**Re: Submission on behalf of One Darling Harbour _ Harbourside Shopping Centre
Redevelopment_SSD7874**

It is our client's submission that the application for concept approval for the redevelopment of the Harbourside Shopping Centre (SSD 16_7874) ought not be approved in its current form.

From the building envelope plans (which depict what the proponent is actually seeking approval for):

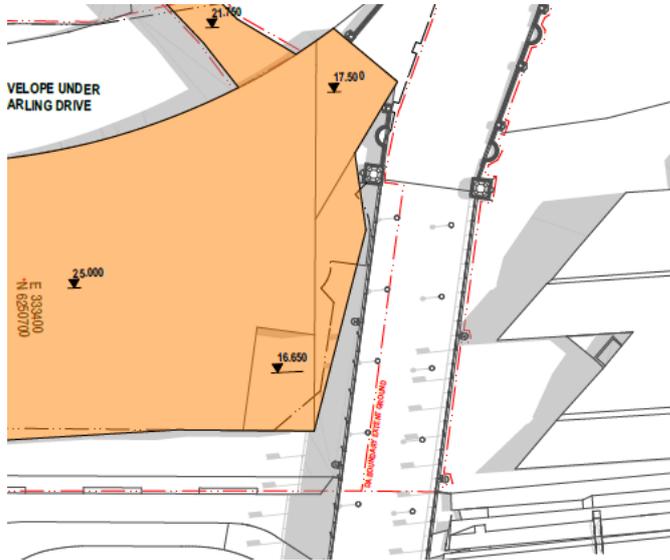
- The proposed building envelope will almost touch the envelope of the pedestrian walkway of Pyrmont Bridge;
- The relative height of the bridge is not specified. However, it appears that the pedestrian walkway of Pyrmont bridge is between 11.5m RL- 13.m RL and the railings are at between 12.5m-14m RL⁵.
- The northern podium will be primarily at 25m RL. The podium will be approximately 7m distant from the bridge at this height. The "lower" triangular segments of the podium (which sit closer to the bridge) are to be 16.5m RL (on the harbourside) and 17.5m west of the bridge buttresses. The height of the proposed podium sliver most directly adjacent to the bridge is not specified.

The podium areas closest to the bridge are actually **higher** in this proposal than in the original proposal. In the original proposal the majority of the northern podium was to be 23.8m RL.

An extract from the "Envelope Plan – Podium" dated 11/2/20 is provided below⁶:

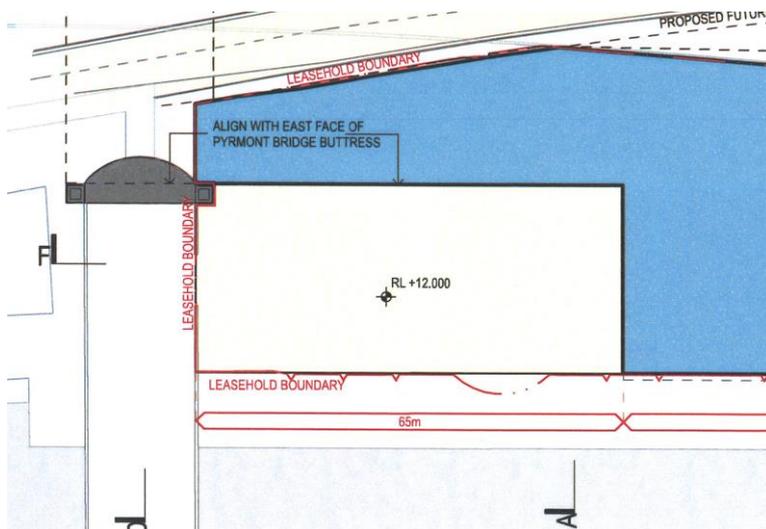
We contrast this proposal with the building envelope approved for the Cockle Bay Wharf Redevelopment (SSD 7684) on the eastern side of Pyrmont Bridge. In that instance, the project application initially sought approval for a building envelope including a tower close to Pyrmont Bridge. In the amended (and subsequently approved application) the tower envelope and podium area was moved, *inter alia*, to provide a more appropriate relationship with Pyrmont Bridge. Relevantly, the approved podium envelope is restricted in height to 12m RL on the western (water) side of the bridge buttresses and 19m RL east of the bridge buttresses. The 12m RL height restriction extends for 65m along the western edge before the envelopes steps up to 29m RL for the tower podium.

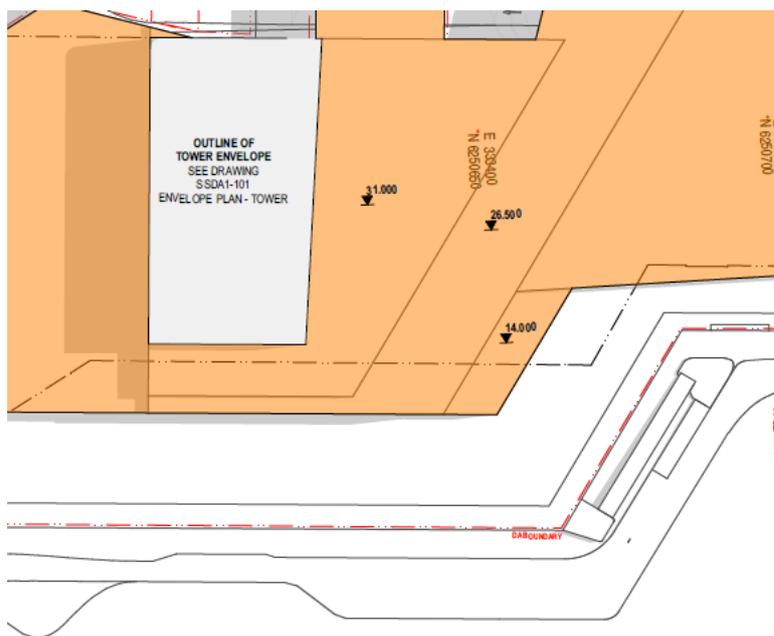
The proposal also includes an appropriation of existing public land east of the current structure that is not assessed in the EIS. The proposed building envelope will encroach approximately 10m into Crown land not subject to the Harbourside lease and the concept plan seeks approval for the placement of retail terraces involving planters, roof canopies, decking, tables and chairs on the waterfront promenade.

We assume from these images that not only will it be necessary for the permitted use of the site under the existing 99 year lease to be amended but also, and more importantly, for the State government to gift a strip of “core” public waterfront land to the proponent.

“Figure 2.1: Amended proposal northern setback and interface between retail podium envelope and Pyrmont Bridge. ... N.B. indicative design only. Future design development in stage 2 DA (Source: Virtual Ideas, 2020)”

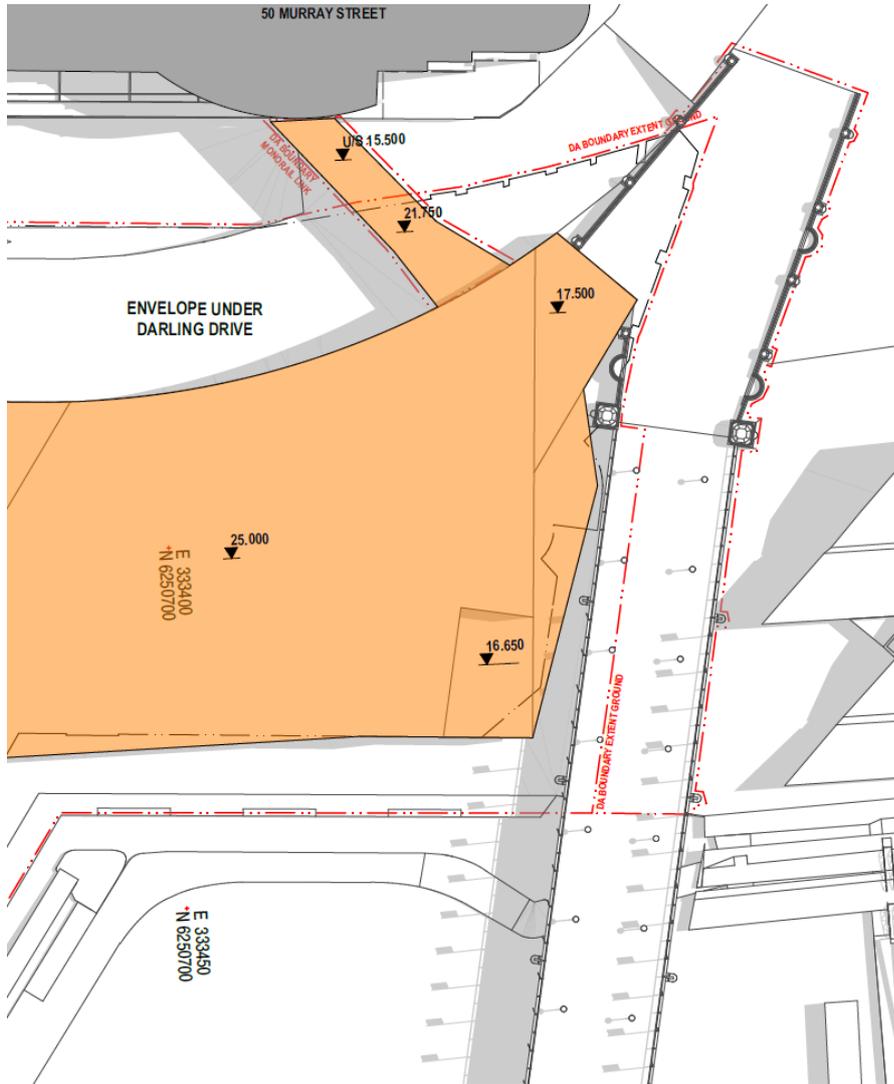
- It is unclear what part of the podium envelope the author considers will have 10m separation from the bridge. Analysis of the proponent's podium envelope plans suggest that the northern podium envelope will touch the bridge envelope and is at widest only approximately 4m from the bridge. Perhaps the author has had regard to the artist's impressions (eg Figure 2.1 in the report) when assessing this impact.

(Note the depiction of the stair/conveyer element sitting below Pyrmont Bridge. In the building envelope proposed this area will have an envelope at least 4m above the bridge. Additionally, note the height at which the commercial office block will sit above the bridge.)

Extract from Plans: “Envelope East Elevation”

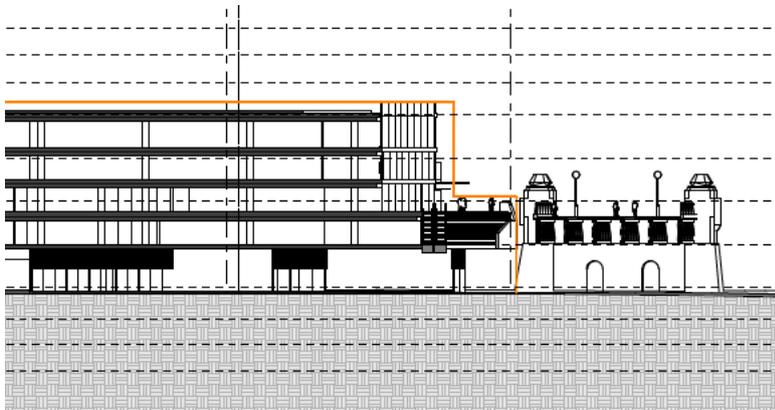
There are inconsistencies in the images provided of the proposal's interaction with Pyrmont Bridge. The building envelope plans, the "indicative floor plans" and the "artistic impressions" all depict *different spatial relationships* between the bridge and the proposed northern retail/commercial podium. Approval is being sought for the building envelope plans. In general, the artistic impressions of the proposal suggest a much lower and more spatially separated podium structure than that depicted in the building envelope plans.

Photograph of existing view taken by client on 23 April 2020

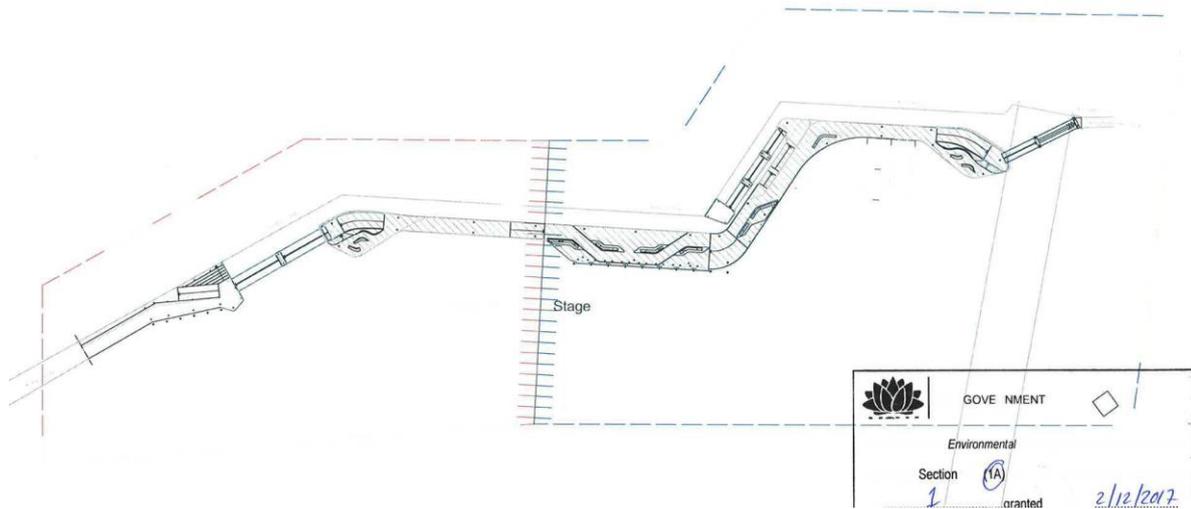
We have set out in **Attachment C** two contrasting images of the proposal. Figure 31 from the Urbis Report providing a drone public domain image and an equivalent photograph taken by our client from Pyrmont Bridge. We note Figure 31 appears to significantly over- represent the public domain area east of the development, and suggests an articulation of the setback of the tower podium at the ground floor and a separation of podium elements not provided in the building envelope plans and provides

(Note the depicted depth of the proposed promenade and the configuration of the pontoon promenade. Also note the different relative sense of height and bulk provided by an aerial image in contrast to an image from the public domain)
